Re: The Idaho-Maryland Mine Project and Final Environmental Impact Report

Community Environmental Advocates Foundation (CEA Foundation) is respectfully submitting these comments on the Idaho-Maryland Mine Project application documents and Final Environmental Impact Report (FEIR). (Mine, Mine Project, Project)

Figure 3-20 Groundwater Movement in Mine Workings

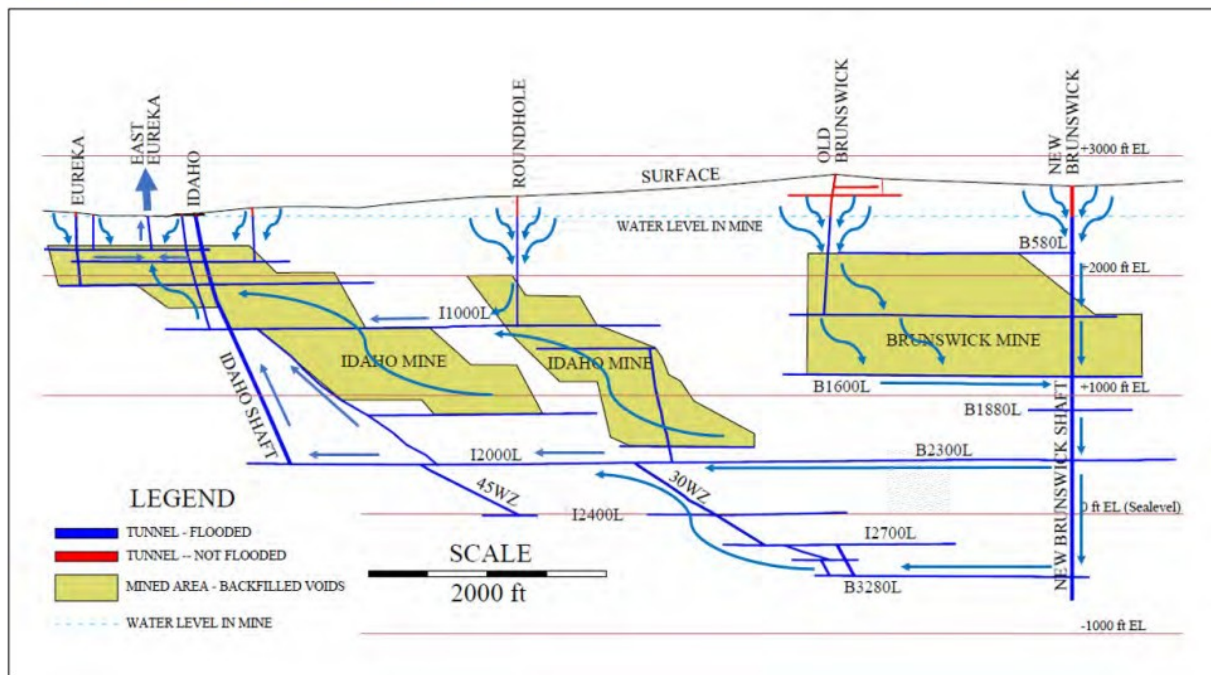
The characterization of the mine water has been misrepresented by the use of samples from the Brunswick Shaft. The FEIR fails to acknowledge this simple point. A single test of the current discharge at the mine drain **after the water has passed through the mine** showed elevated levels of arsenic. This limited testing is inadequate. The concentrations of contaminants may vary with flow rates and may depend upon the amount of near surface inflows to the mine. The EIR should have tested the drain waters repeatedly over time to assess the pollutant concentrations during different flow conditions.
